Access Compliance Report Public Rights-of-Way (Curb Ramps)

Intersection ID: N/A Main Street: EASTWAY_DR Cross Street: N/A Location: NW

ADA ID: A152B1D3EEF4 Ramp Type: PerpDiag Initial Pass/Fail: Fail Overall Compliance: No Severity Score: 10

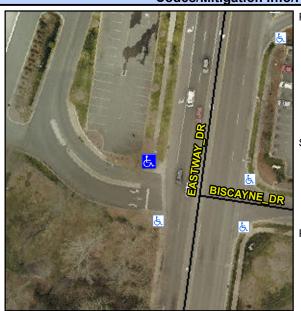
PROW/ADA:
Not Found, R304.5.1, R304.5.3

Remove & Replace Curb Ramp With Two New Directional Ramps or Equivalent.
